THURBER ENGINEERING LTD.

MEMORANDUM

Date: November 17, 2021

OVERVIEW GEOHAZARD ASSESSMENT - FURRY CREEK LANDS PRELIMINARY GEOTECHNICAL REVIEW OF PROPOSED SCHOOL SITES

Figure 1. North Site (modified from SCH-KEY-1 File No. 14305 Rev 2, provided by CREUS). Boundary of Furry Creek Lands indicated by red dashed line.

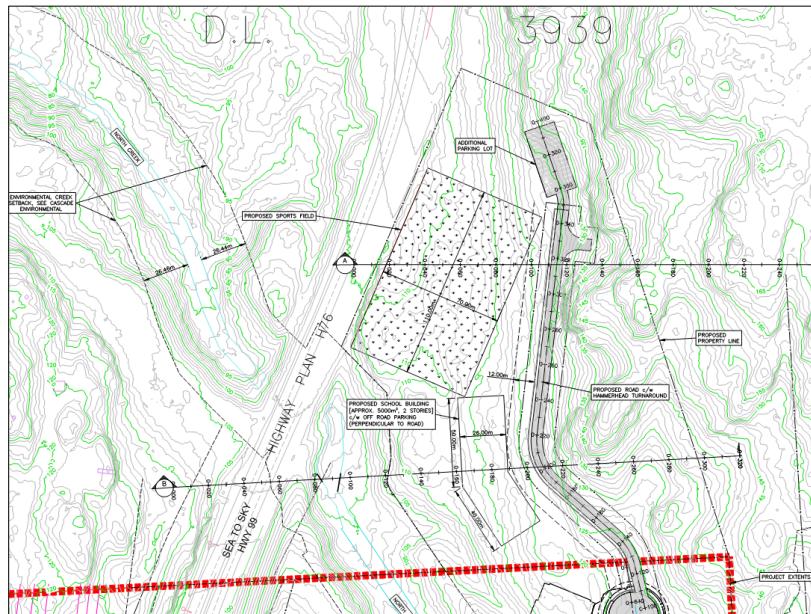
The north site is located to the north of the Furry Creek lands in a forested area bordered by Highway 99 to the west and by North Creek to the south. Sketch SCH-KEY-1 provided by CREUS shows an approx. 5,000 m² two-storey school building plus an adjacent sports field and access road.

The north site was much more moderately sloping as compared to the south. Bedrock exposures were generally limited to eastern portion of the site, east of the proposed driveway, and appeared to be somewhat limited in height. The exposed bedrock appeared to be generally massive with very wide to extremely wide joint spacing. Further, the bedrock was rounded and showed evidence of being glacially scoured on the surface. Most of the site appeared to have been previously logged and there was very little undergrowth below the tree canopy. Some surface water was noted flowing along a minor topographic low near the north/south midpoint of the site.

Figure 2. South Site (modified from SCH-KEY-2 File No. 14305 Rev 2, provided by CREUS). Boundary of Furry Creek lands indicated by red dashed line.

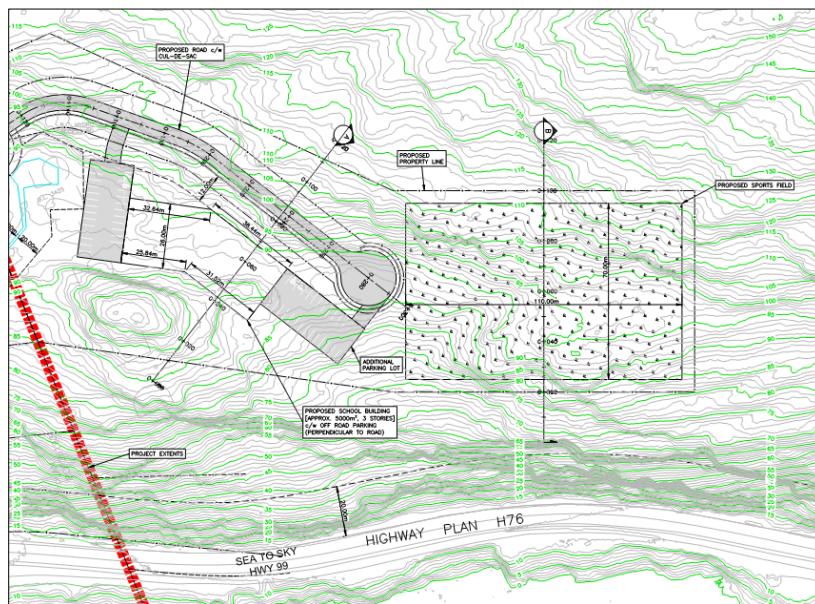
The south site is located to the south of the Furry Creek lands in a forested area bordered by Highway 99 to the west and by the Porteau Bluff / Benchlands neighbourhoods to the north. Sketch SCH-KEY-2 provided by CREUS shows an approx. 5,000 m² three-storey school building plus an adjacent sports field and access road.

The south site had steep, bedrock-controlled topography with many exposed bedrock faces and in general has much more rugged terrain compared to the North Site. The bedrock has a wide to very wide jointed structure with prominent joint sets comprising near vertical joints as well as joints dipping toward the west (i.e., daylighting out of the slope). This is similar to the sheet jointing pattern seen in the bluffs along Highway 99 below the site. There were very large boulders covering much of the ground surface below the bedrock faces. Vegetation comprised very mature trees, particularly on the southern portion of the site.

Figure 3. Plan view of the north site showing the runout path (indicated by coloured shading) of a hypothetical 5,000 m³ debris flow on North Creek.

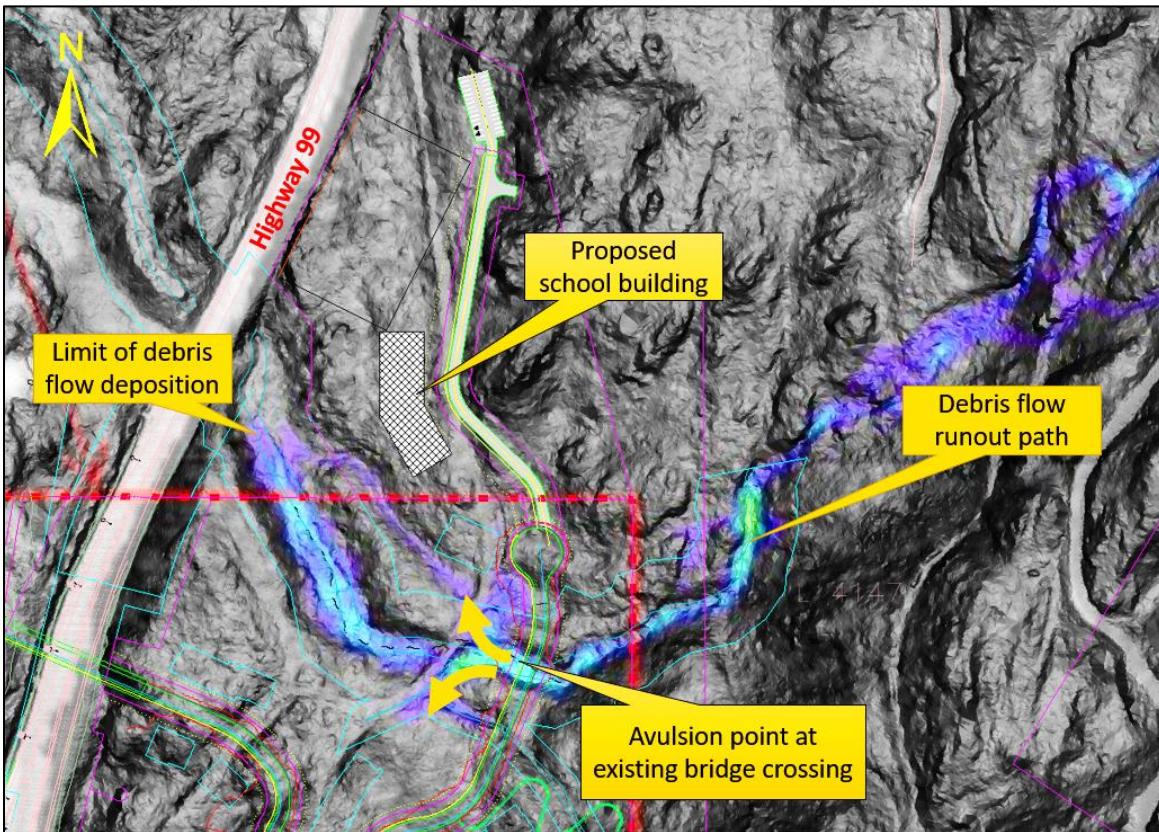
From Figure 3, it can be seen that the north site is not impacted by the modelled 5,000 m³ debris flow, although there is some avulsion of material out of the channel at the existing bridge crossing. Implications for development of this area are discussed in Section 4.1.

Figure 4. Isometric view of the north site showing the modelled rock fall paths (trajectories) from upslope. Red lines are rock fall paths; school site is circled in yellow.

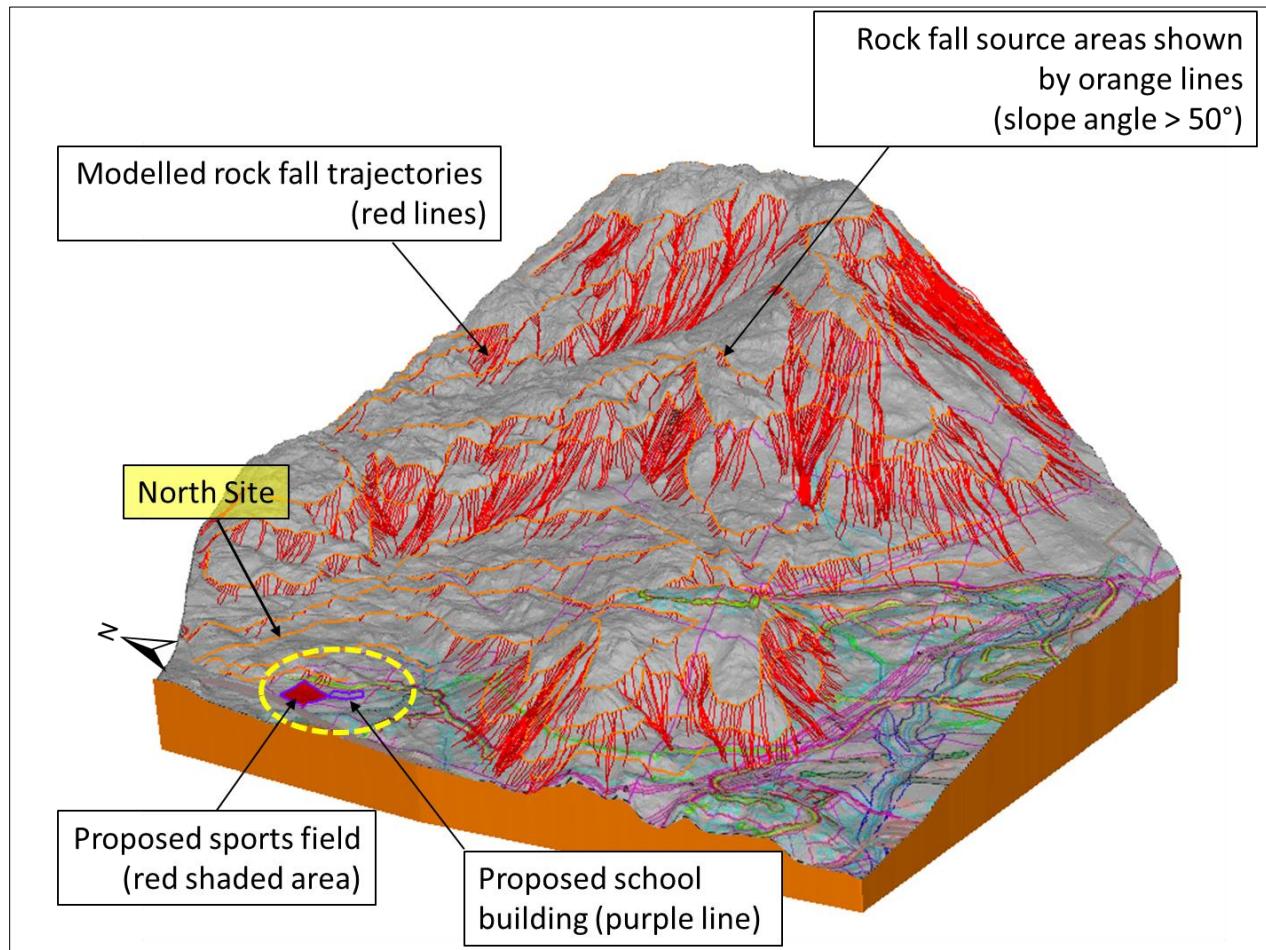
From Figure 4, it can be seen that the north site is not impacted by rock falls sourced from the steep mountain ridges high upslope, although the proposed access road could be impacted by localized rock falls from the adjacent bluffs. Implications for development of this area are discussed in Section 4.1.
